Packet Guide
City of Charlottesville
Board of Architectural Review
Regular Meeting
April 15, 2025 5:30 p.m.
Hybrid Meeting (In-person at Council Chamber and virtual via Zoom)

Recommendation for Special Exception Permits

Permit # PL-26-0126

Certificate of Appropriateness Application

PROPOSED SITE PLAN WITH REQ'D CITY TREE PROTECTION REQUIREMENTS

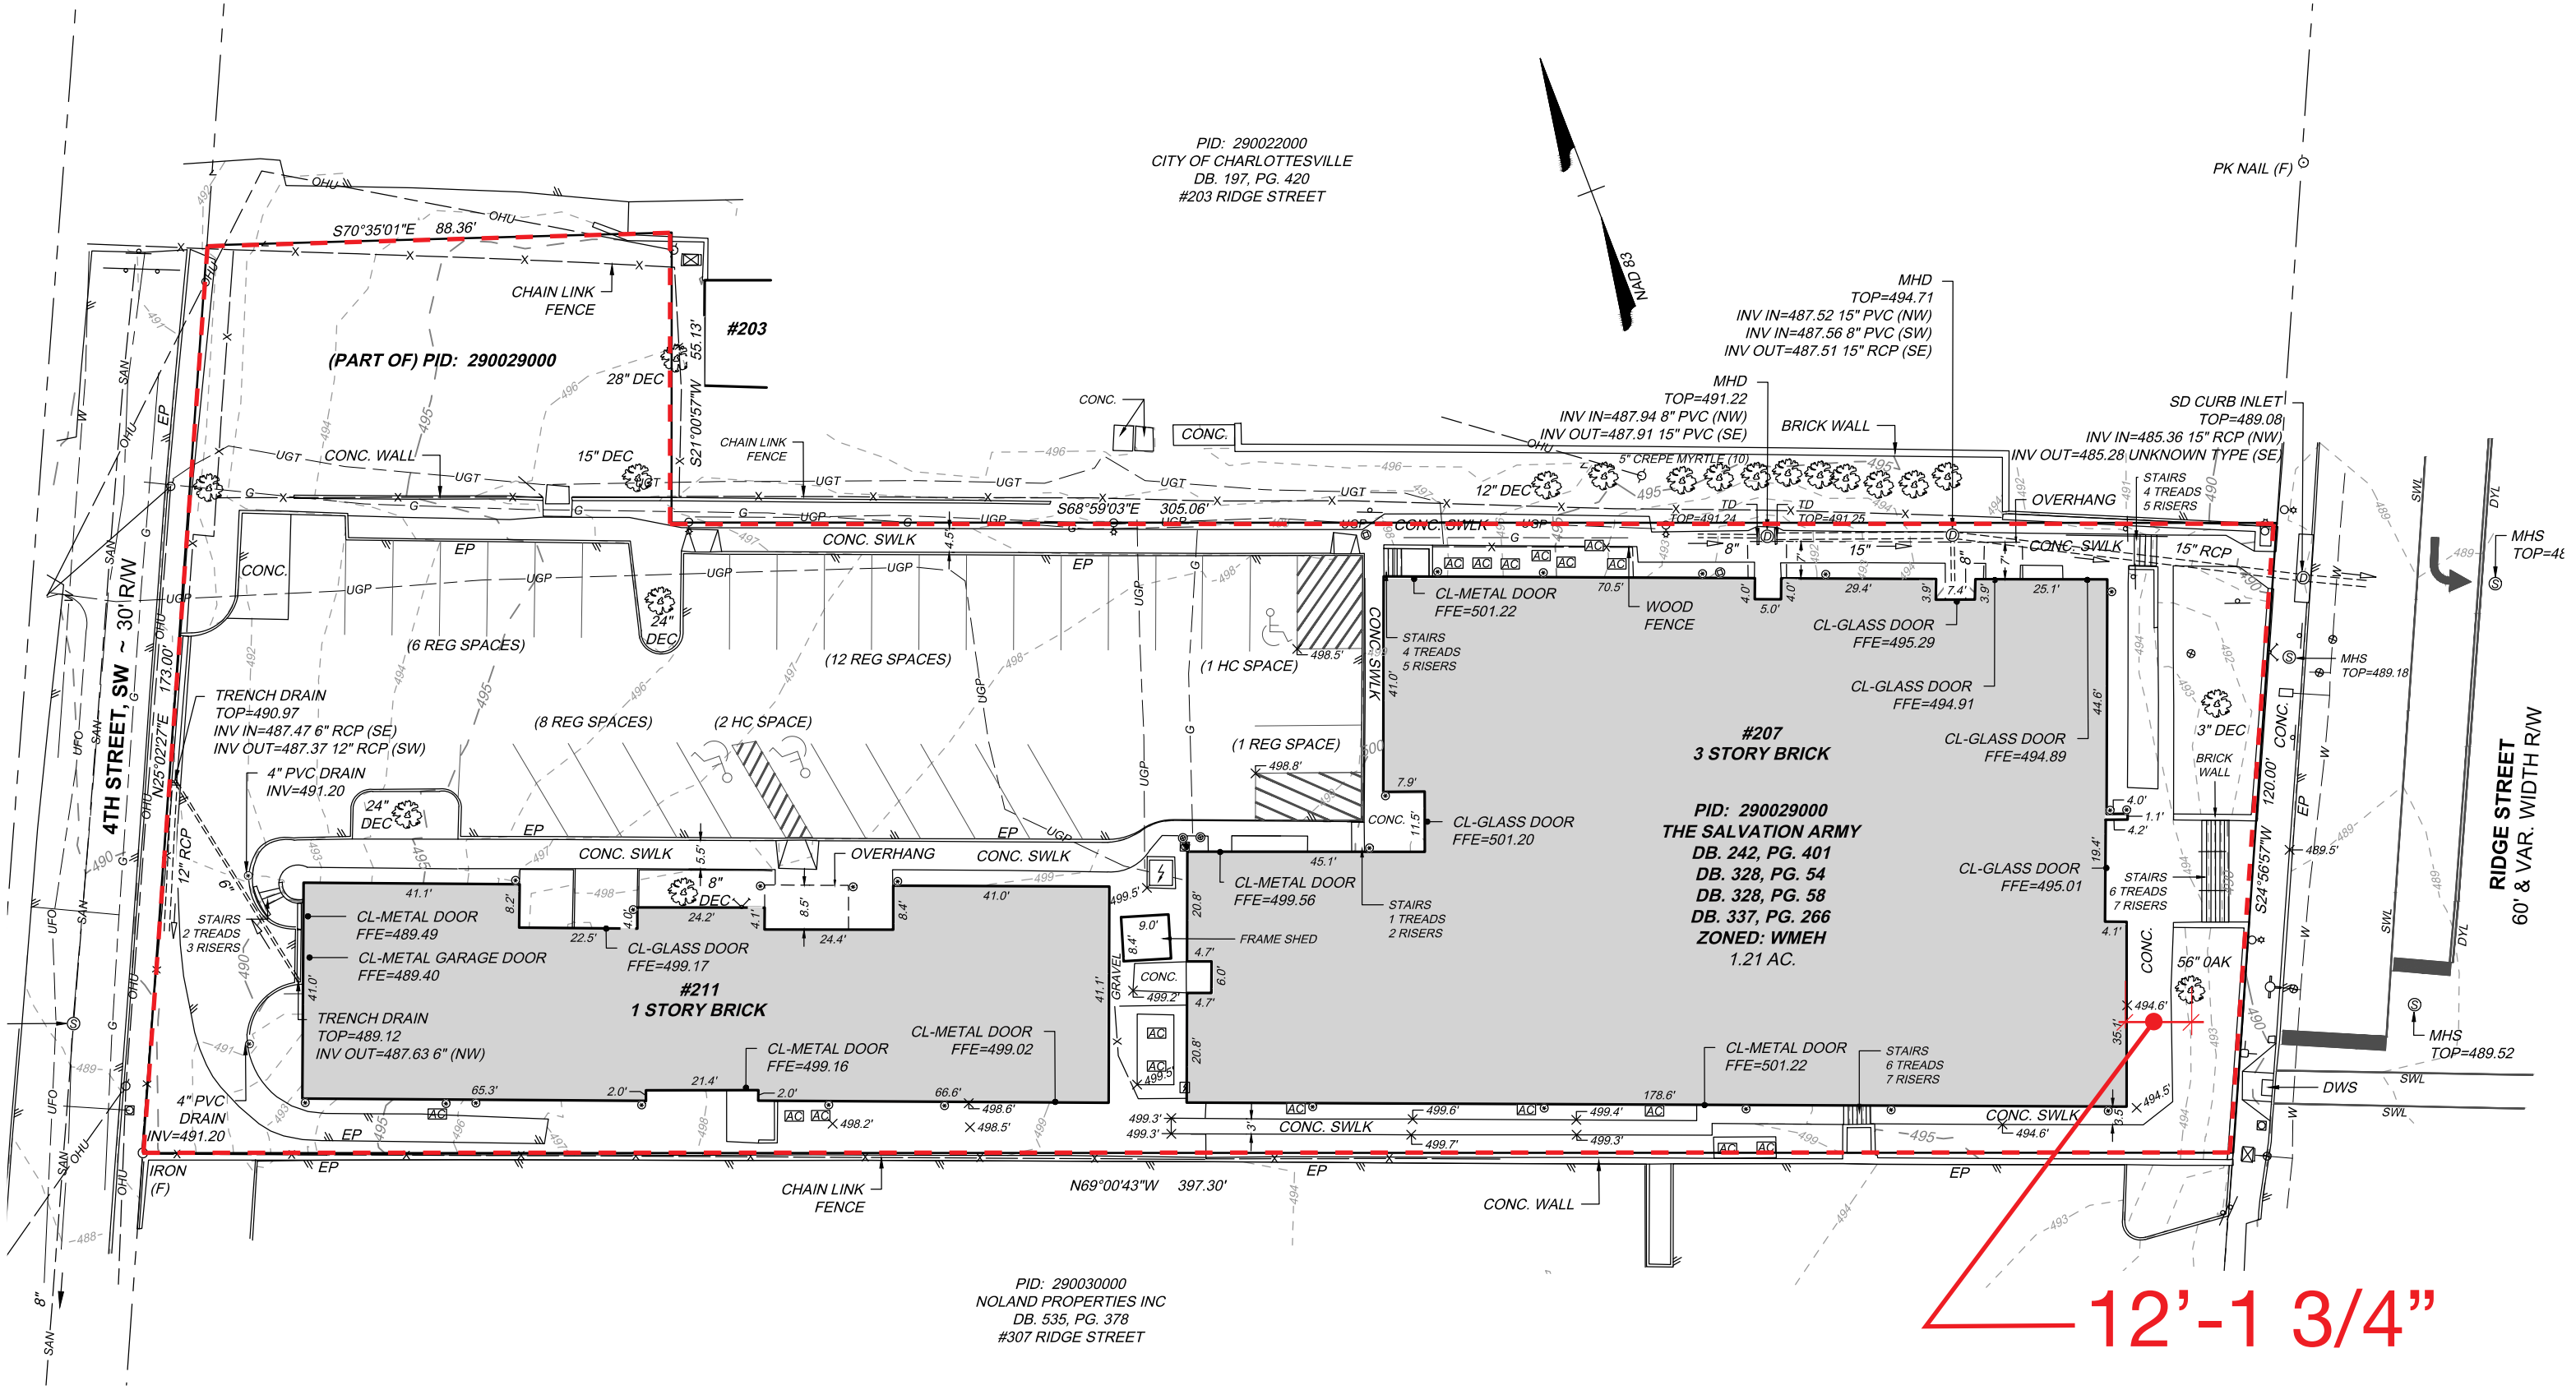
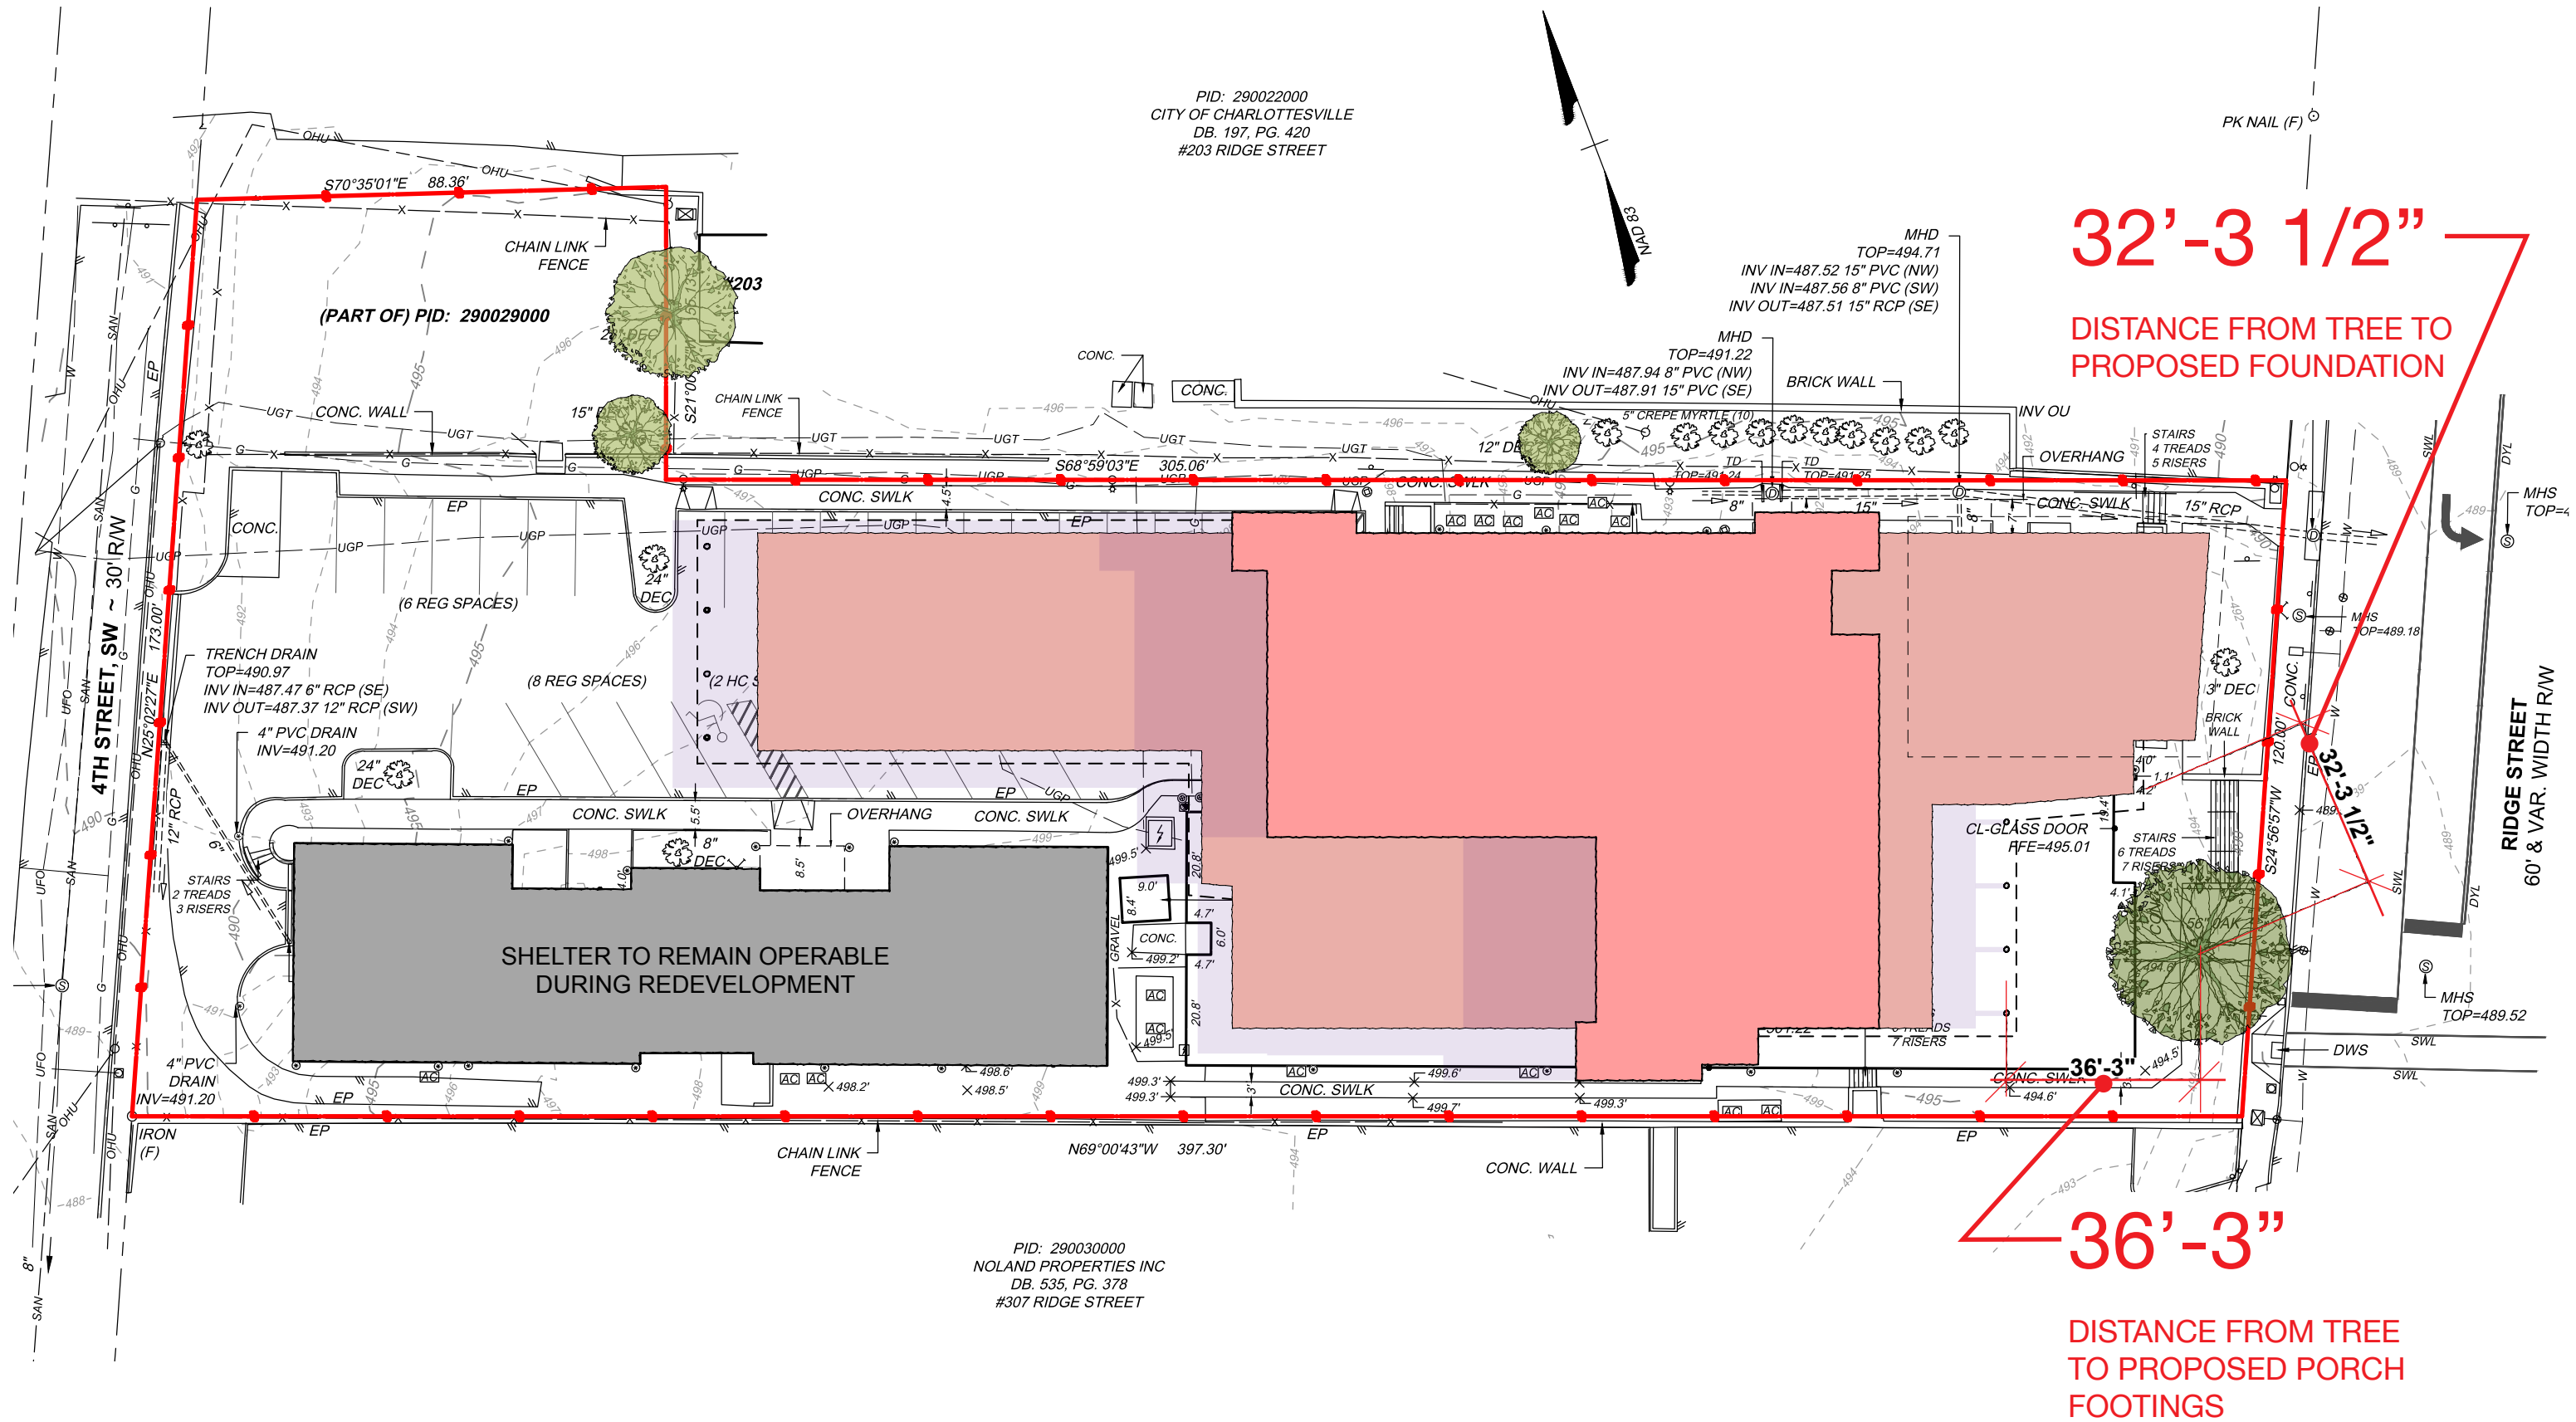
- The BAR does not find that the removal of the black oak at the front of the property is compatible with the guidelines and asks that the applicant develop a tree protection strategy based on the arborist recommendations submitted January 16, 2023. The applicant should apply all reasonable approaches to protect the tree during demolition and subsequent construction.
- The BAR recommends that the city engineer work with the applicant to review the tree protection plan that they have developed and adapt the city requirements to the particular context of this situation.
